earlier model · under review

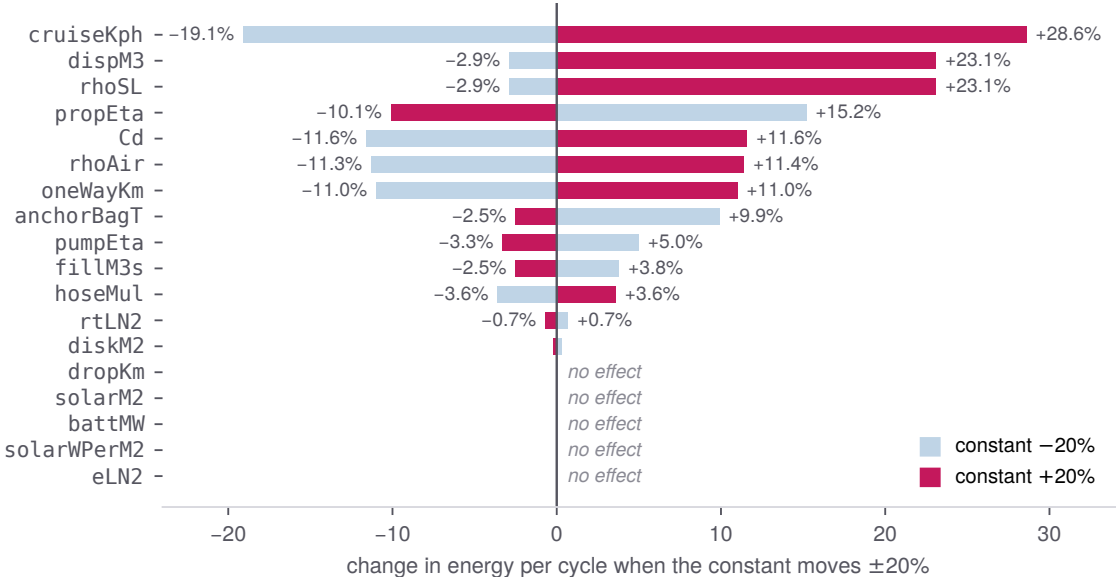
These energy figures come from the earlier flight model, which understates the force needed to hold an empty hull down. Corrected figures will be higher, and some cycles may not be flyable as drawn.
